Groundwater Application Review Summary Form

Application # G- 19072

PUBLIC INTEREST REVIEW FOR GROUNDWATER APPLICATIONS

TO: Water Rights Section Date 8/8/2023
 FROM: Groundwater Section Dennis Orlowski Halley Schibel/Travis Brown
 REVIEWER'S NAME
 SUBJECT: Application G- 19072 Supersedes review of 2/17/2022
 Date of Review(s)

Water-Level Measurements in Nearby Wells

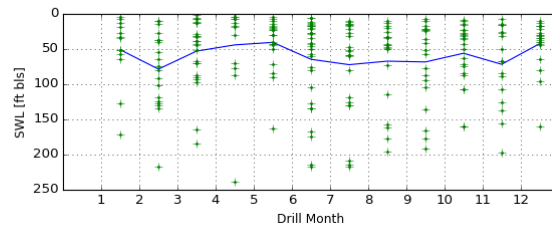
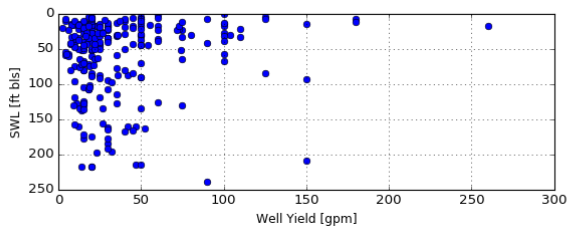
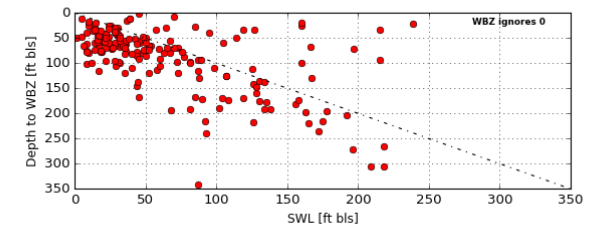
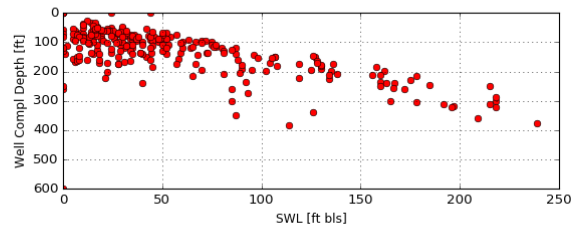
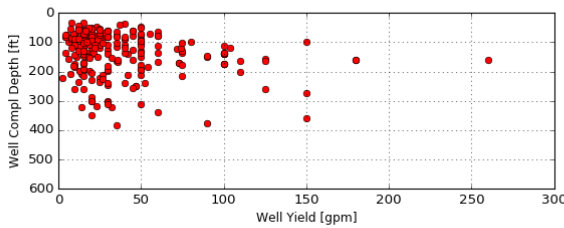
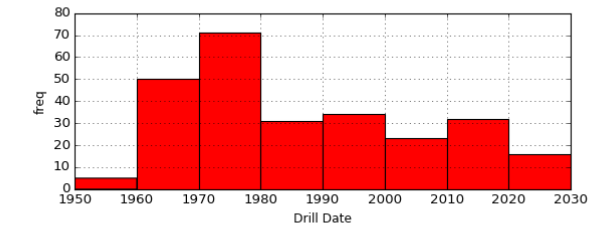
Nearby observation wells include wells on permits with static water level reporting conditions, which have measurements on record since the early 2010's. These wells do not appear to show excessive, area-wide declines, although CLAC 66847 and CLAC 66853 appear to show a slight decline over the last four years.

Available groundwater level data from nearby wells completed in the Willamette Aquifer do not suggest any clear declining trend over the periods of records. Furthermore, the available water level record does not meet the Division 8 definition of excessively declining or declined excessively.

Theis Drawdown and Recovery at $r = 580$ ft From Pumping Well

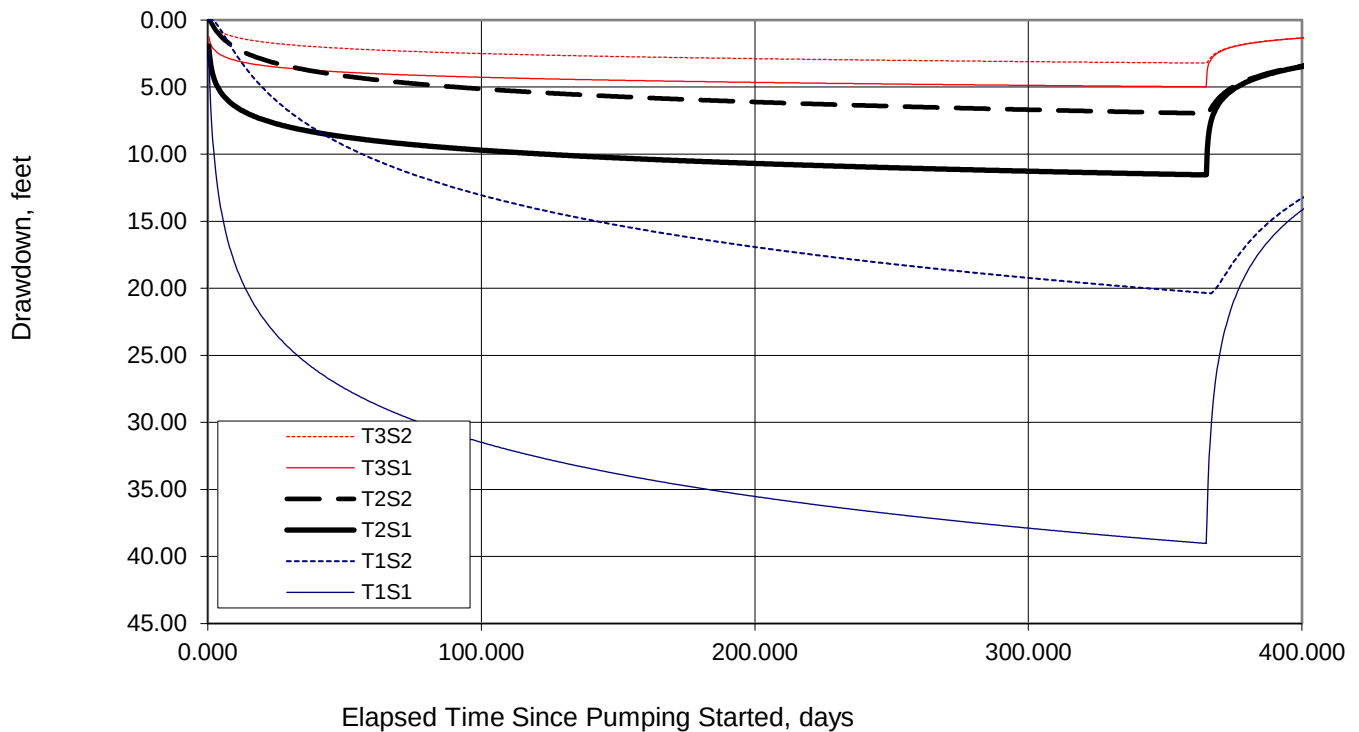
- B3. **Groundwater availability remarks:** The proposed POAs are located in the Central Willamette Valley and will produce from strath terrace deposits (Madin, 2004) consisting of sand and gravel (the Willamette Aquifer described by Gannett and Caldwell, 1998), which overlies fine-grained distal alluvial fan and low gradient stream deposits locally separated by thin layers of sand and fine gravel (Willamette Confining Unit). The Willamette Aquifer is estimated to be ~100 ft thick in this location. The majority of wells in the immediate vicinity draw water from the Willamette Aquifer. The requested rate (0.056 cfs) is well within the range of reported yields for water wells in this area (see attached well statistics) and is unlikely to injure the closest neighboring well, CLAC 5188 (see attached Theis analysis), which is ~580 ft to the northeast.

In order to protect the groundwater resource and neighboring users, the conditions specified in B1(d)ii and B2(c), above, are recommended for any permit issued pursuant to this application.

Hunt (1999) Stream Depletion Model Analysis

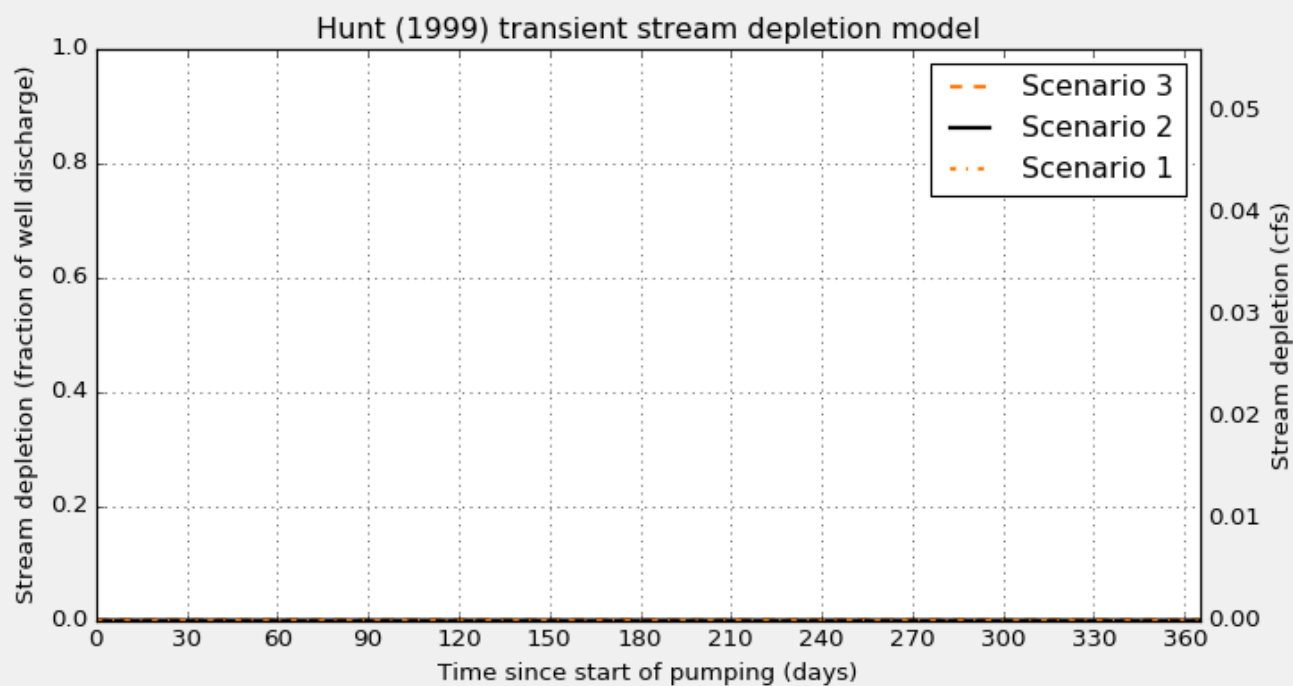
C6. **SW / GW Remarks and Conditions:** While net impacts to surface water will likely be small at the onset of pumping, stream depletions will increase with time until a new equilibrium between local recharge and discharge is reached. Because SW 1-3 appear to issue from springs fed by the aquifer tapped by the proposed POAs, it is anticipated that, eventually, all water consumed from the proposed POA will be depleted from local streams. Since the proposed POAs and the nearby streams are above the Clackamas River State Scenic Waterway, 100-percent of the consumptive use of water from the proposed POA will eventually result in an equal and measurable depletion of surface water flows necessary to maintain the free-flowing character of the Clackamas River State Scenic Waterway.

- C5. ☒ **If properly conditioned**, the surface water source(s) can be adequately protected from interference, and/or groundwater use under this permit can be regulated if it is found to substantially interfere with surface water:
- i. ☒ The permit should contain condition #(s) 7j (State Scenic Waterway Condition);
 - ii. ☐ The permit should contain special condition(s) as indicated in "Remarks" below;
